ON-SITE SEWAGE DISPOSAL SYSTEM HOWARD COUNTY HEALTH DEPARTMENT BUREAU OF ENVIRONMENTAL HEALTH

ADDRESS: 7013 Meandering Stream Way PROPERTY OWNER: Eshelman

Re: Pool and Sunroom Proposal
SDA Adjustment
7013 Meandering Stream Way

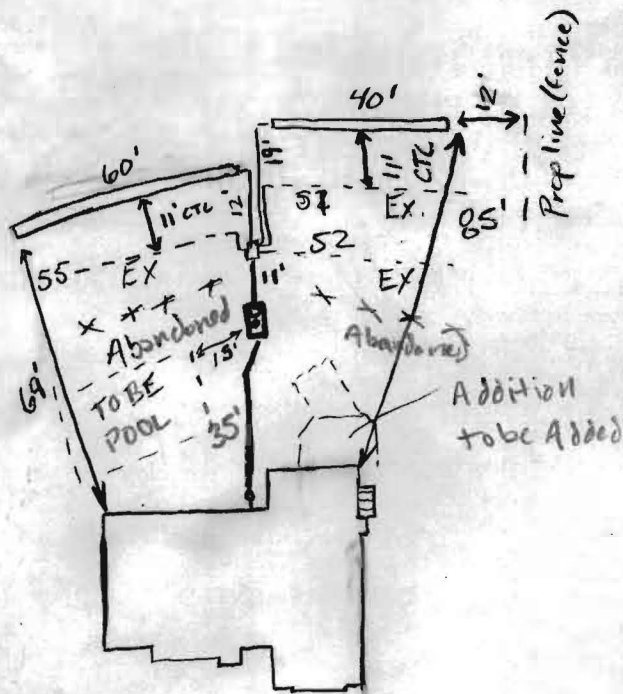
TRENCHES:	Trench to be 3.0 feet wide. Inlet 4.0 feet below original grade. Bottom maximum depth 7.0 feet below original grade. Effective area begins at 4.0 feet below original grade. 3.0 feet of stone below distribution pipe.
LOCATION:	Disconnect the two highest trenches. Install two more trenches 50' long each 10' center to center of the existing middle trenches to remain.
NOTES:	Purpose of permit is for future pool location. Pool location no closer than 20' to trenches in order to support building permit approval for the pool. Building permit to be signed after pool layout staked & 20' setback requirement confirmed.

PRE-CONSTRUCTION See pink page dated 2/21/06. 3/7/06 abandon the two topmost trenches as allowed for in permit to support BP for pool & Sunroom addition

INSTALLATION install 1x60' trench & 1x40' trench to the appropriate sides of the basement to make up for abandonment of uppermost trenches. (GAC) Run trenches 9" or 8 1/2" edge to edge. (GAC) Pool layout now appropriate.

3/8/06 Final inspection system upgrade installed per instruction 2 uppermost trenches abandoned, extra 2 added below existing. OK for BP(s). (GAC) All setbacks met at this time from painted outline of proposed additions. (GAC)

PLOT PLAN
 SINGLE FAMILY
 DWELLING
 7013
 7025 MEANDERING STREAM WAY
 LOT 27 PINDELL WOODS
 HOWARD COUNTY, MARYLAND

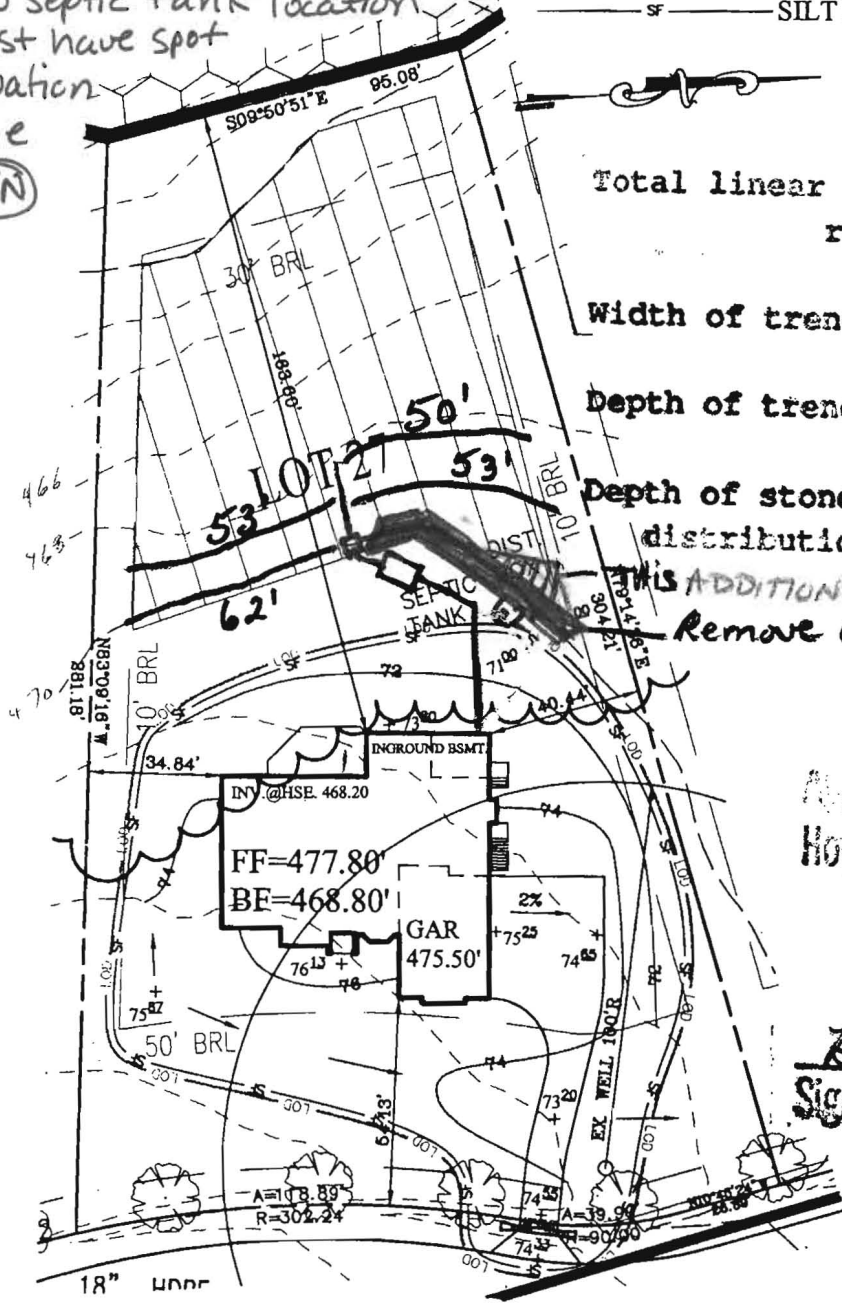
12-8-C1, SDA SHOWN = 11,198.772 **A** CALCULATIONS AND ADJUSTMENTS
 support removing a high trench & relocating new trench lower

Called \bar{o} for plan submittal.
 New septic tank location
 must have spot
 elevation
 done
 (KN)

This ADDITIONAL AREA MAY BE REMOVED
 Remove 62' x 5' = 31 of 42

Review of your adjustment of the septic area for the construction of a pool and sunroom appear to meet COMAR regulations. Current SDA is approximately 11, 198 square feet. Your proposal to relocate two trenches and place the pool and sunroom in the vicinity of the upper SDA removes a total of 1,110 feet more or less. Approximately 450 square feet can be added to the lower left hand corner of the SDA but no more due to steep slopes.

By allowing the adjustment of the septic area, future increase in bedrooms may not be allowable unless trench layout proves otherwise. In order to accommodate any future increase in flow, we recommend the two relocated trenches to be slightly deeper than necessary to allow more sidewall adsorption area.

Enclosed is a copy of the site plan, to scale. Resubmit an official copy of the location of the pool and sunroom, grading around them, and the new location of the septic tank with inverts. Once our office receives the plan, we may issue the septic upgrade permit upon payment of \$395.00, check written to Director of Finance.

PLOT PLAN
 SINGLE FAMILY
 DWELLING
 7013
 7025 MEANDERING STREAM WAY
 LOT 27 PINDELL WOODS
 HOWARD COUNTY, MARYLAND

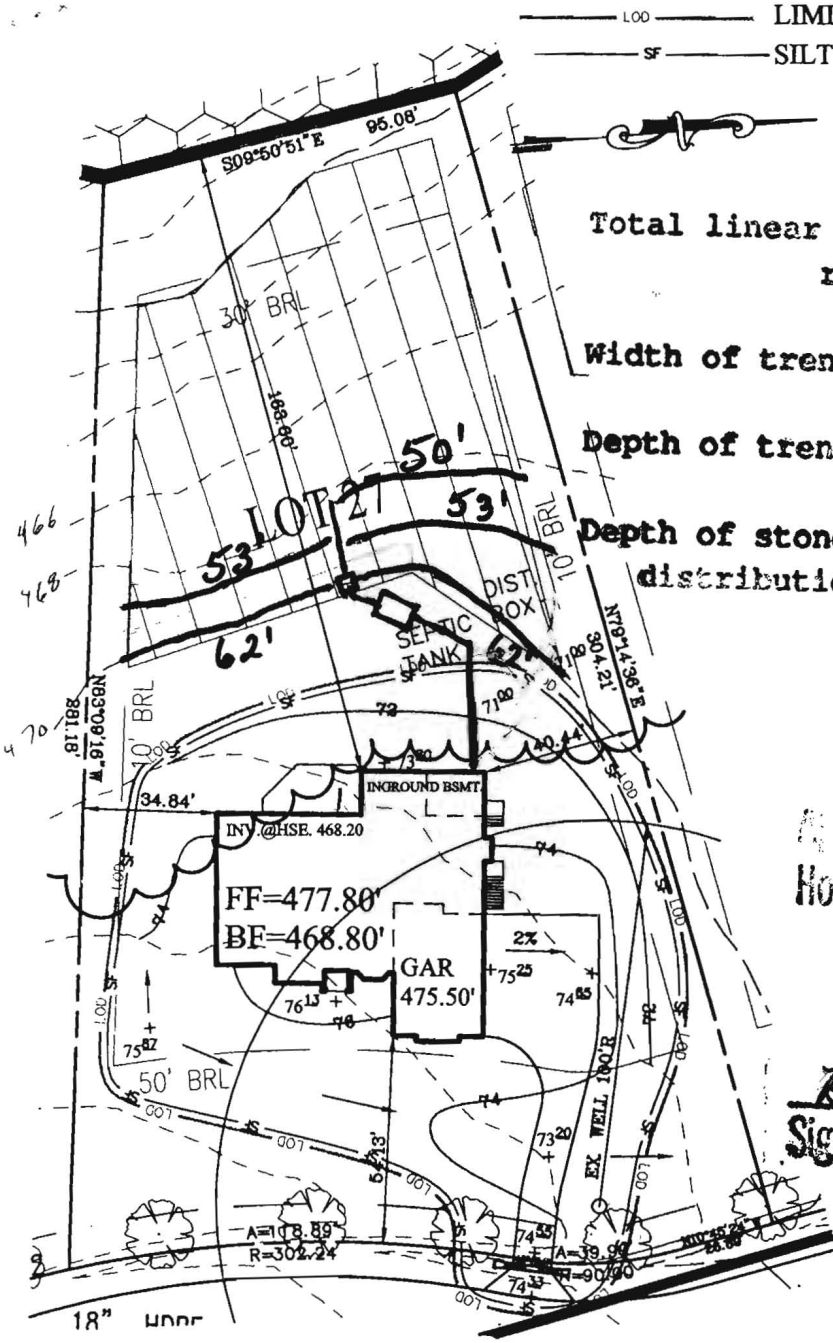
I have had recent discussions with KC Noonan from your office regarding this matter. She scaled off my current SRA at 11,198 square feet and indicated on the marked-up plot plan that I could relocate to the rear of the 50' trench, the 62' trench immediately to the right of the distribution box ("DB"). Upon further review, I would like to additionally relocate to the rear of the 53' trench on the left, the 62' trench to the left of the DB. This would allow me to also relocate that much further to the rear of my lot, the septic tank and DB (I am enclosing a copy of the as-built which indicates the true location of these facilities). I've attached a preliminary pool design illustrating this improvement parallel to the existing SRA. Together with pool patio decking, this design is fairly tight. Relocating the 62' trench and removing the corresponding SRA would provide relief on this issue. I assume I have a surplus of 1,198 square feet of SRA which I could loose (10,000 square feet SRA being the minimum). If I needed to pick-up some additional SRA, it appears that I have an unused area of approximately 500 square feet located within the left rear corner of my lot that per the contour looks to be of even less slope than other spot areas within the SRA.

In summary, essentially my request centers on vacating the portion of the SRA between the two (2) 53' trenches and my house footprint and if needed, squaring off the SRA in the left rear corner of my lot. Thank you in advance for your attention to this matter and should you have any questions upon review, please contact me at the phone number listed above.

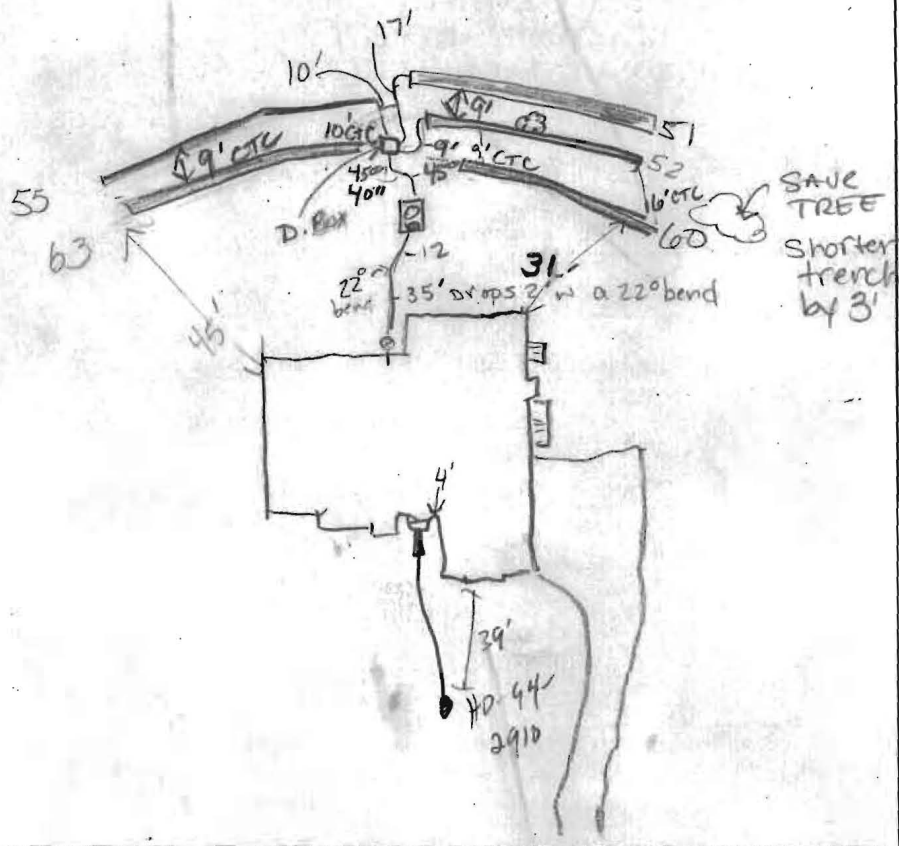
PRE-CONSTRUCTION 8/19/02 lot staked, house corner changed, trench layout per BP. (SO) 9/16/02 2nd layout, same as before (SO)

INSTALLATION 9/17/02 OKAY TO COVER two trenches OK TO SHORTEN TRENCH ON RIGHT SIDE CLOSEST TO DRIVEWAY TO SAVE the tree - Ron wants 3' - OK'd. Ensure D.Box is cleaned out & water test (KN) 9/18/02 3 trenches installed - OK TO COVER. D.B. level. OK'd moving trench on right 1 foot closer to house to save tree per owner's request. Shot contour with contractor. OKAY TO COVER ALL WORK (KN)
